**NOTICE OF MEETING**  
**PLANNING AND ZONING COMMISSION**  
**6:00 P.M. – February 13, 2020**  
30360 Cougar Bend, Bulverde, TX 78163

PLANNING AND ZONING COMMISSION ITEM:  
PC-20-01  
**PRELIMINARY PLAT**  
PRESERVE AT SINGING HILLS, UNIT 5

## REVIEW MEMORANDUM

## REVIEW MEMORANDUM

SUBDIVISION PLAT  
ESTABLISHING  
**THE PRESERVE AT  
SINGING HILLS, UNIT 5**

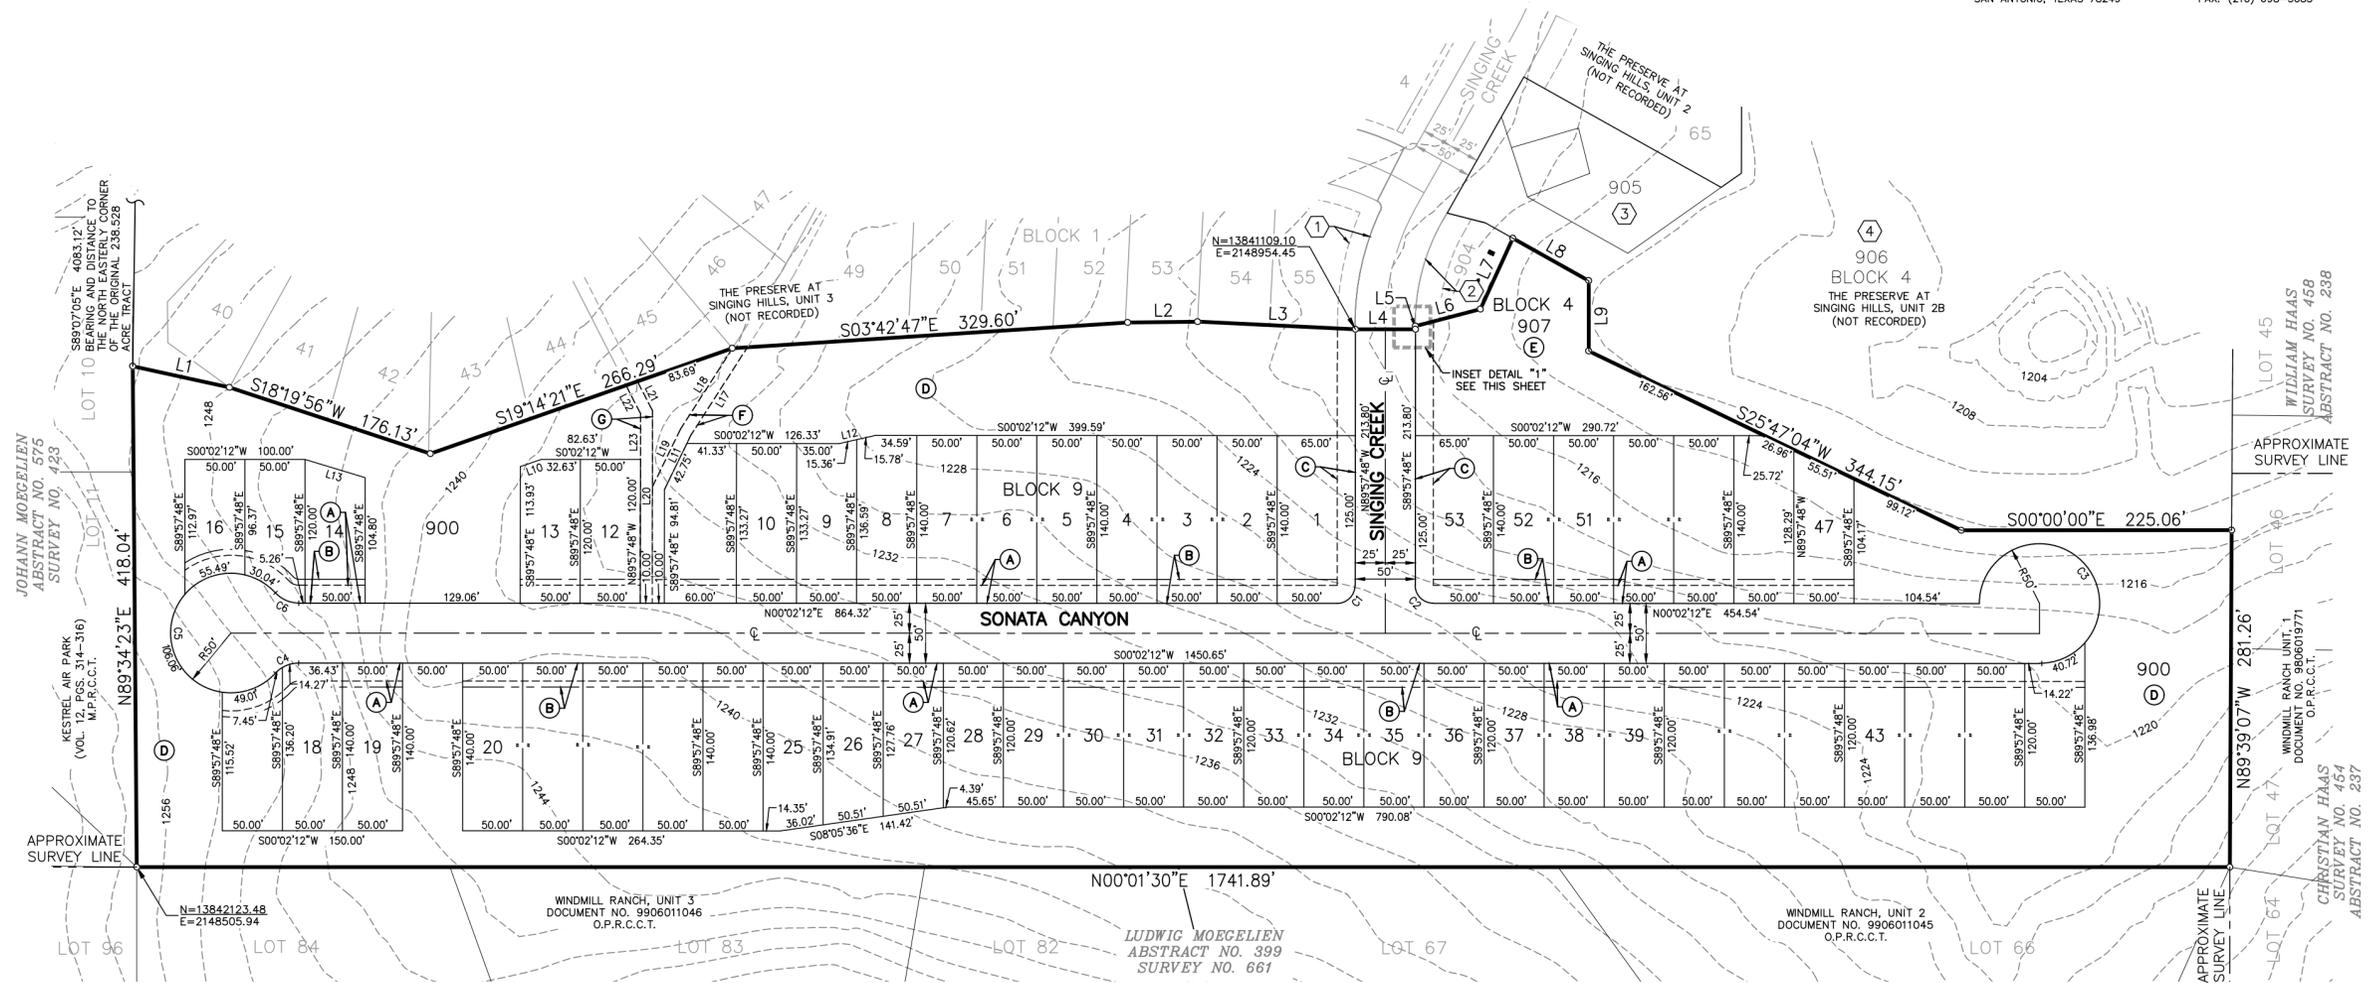
1. Several lots are missing lot #'s
2. Each lot needs an acreage callout
3. Update subdivision note 1 (preparation date) and 6 (acreage/LF ROW dedication).

4. Plat adds 13 lots and increases master plan lots from 318 to 331. TIA assumed up to 350 residential homes, so this increase does not change the traffic impact analysis – **no response required.**
5. Missing drainage analysis to accept offsite runoff. A significant amount of runoff is being received by this development and not enough information is provided to prove 100-YR flows are contained within drainage easement. HEC-RAS model was provided for the original plat. Show offsite drainage area delineation and supporting calculations for runoff to be received.

SUBDIVISION PLAT  
JOHNSON RANCH  
NORTH - UNIT 9  
COMAL COUNTY, TEXAS

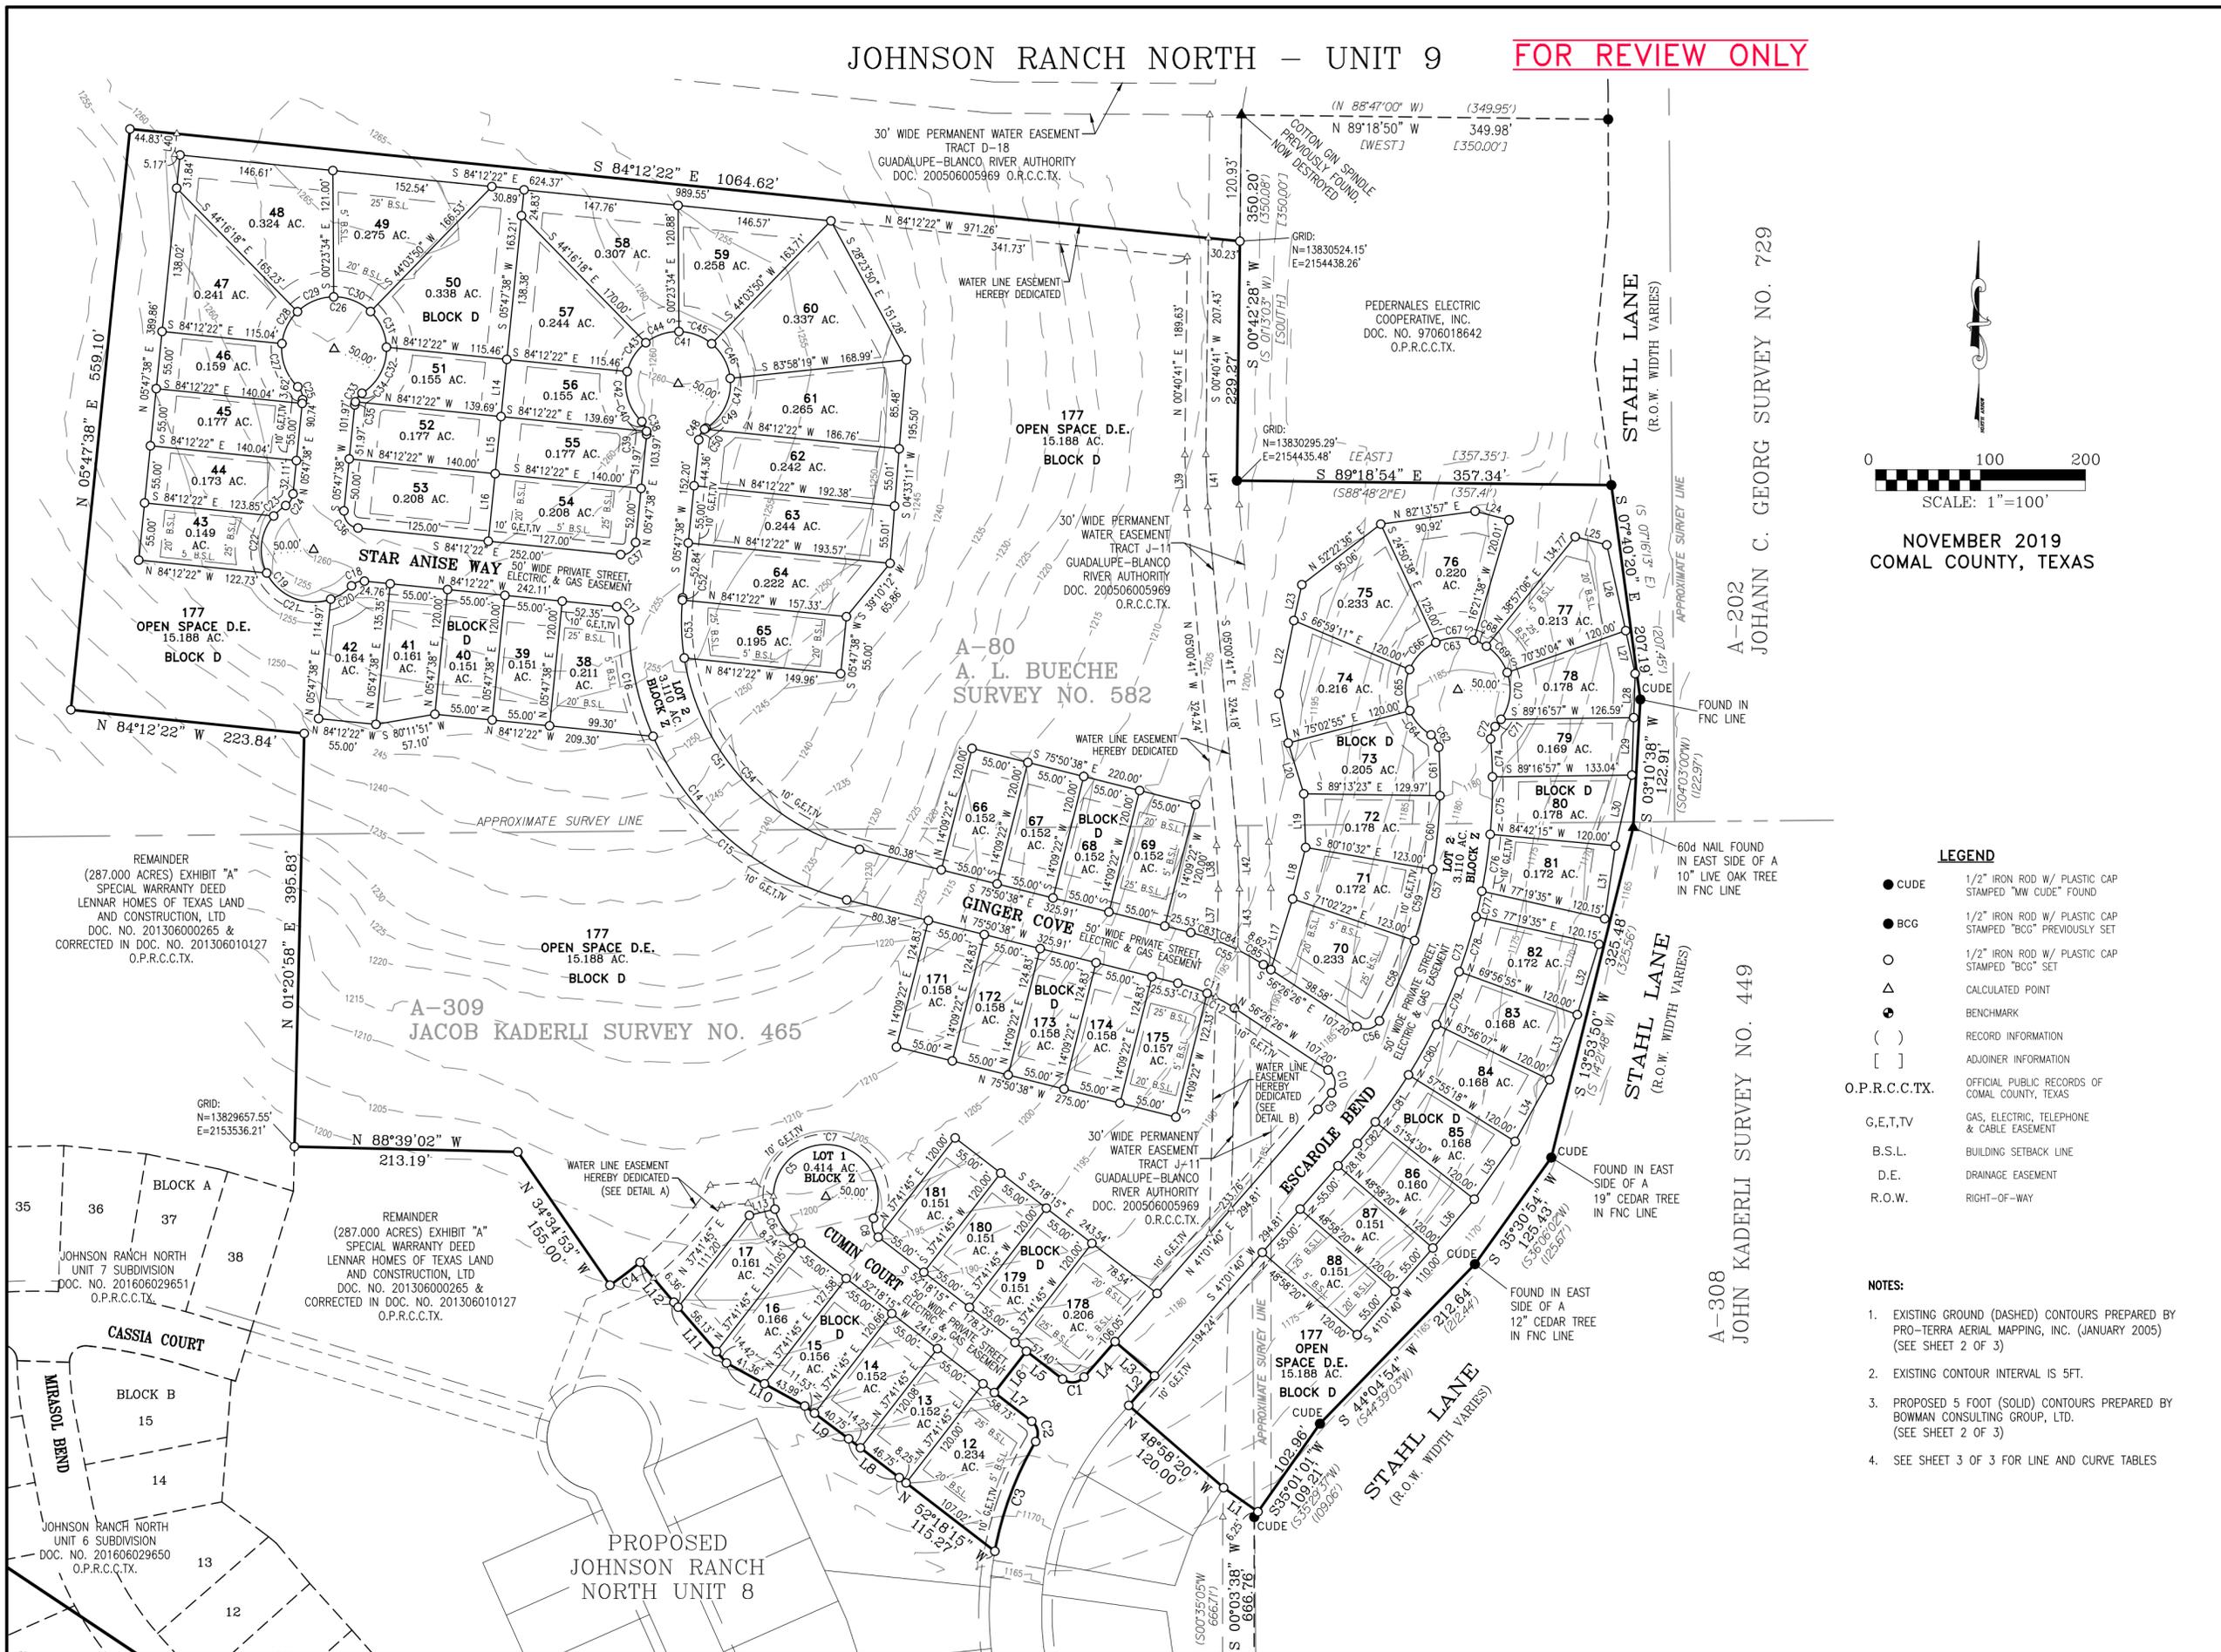
1. Per the City's adopted Transportation Master Plan, Stahl Lane is classified as an arterial roadway (86' ROW). Additional ROW dedication is needed along the eastern property boundary.
2. Developer Agreement Exhibit 'C' – Unit 9 consists of 31.363 acres and 66 residential lots, averaging 1 lot per 20,700 square feet of gross land area. This exceeds the one residential lot per 30,000 square feet allowed. Please provide cumulative calculation of single family lots platted vs. total lots allowed per developer agreement section 3.02.

3. Unit 9 appears to vary from the Master plan acreage and lots.

4. 1.05(b) – Plat indicates only one (1) Block 'D' for all lots. Residential lots are separated by Open Space and as well as front various streets within Unit 9. Additional Blocks should be delegated within Unit 9.
5. 1.05(b) – Provide Bearing and Distance dimension from a corner of the subdivision to a corner of the original tract or original survey.
6. 1.05(b) – Show City limits and limits of City's ETJ on Vicinity Map.
7. Lots 59-64 exceed the "Aspect Ratio" that lots be no greater than 3.5:1 unless approved by City Planning Director or City Engineer. Lot dimensions appear to be within acceptable intent of the Aspect Ratio, therefore no corrective action is recommended. – **No response required.**
8. Plat margins are incorrect. Left margin should be 2". Top, right and bottom should be ½"
9. Metes and bounds description of the subdivision property must be included in the plat.
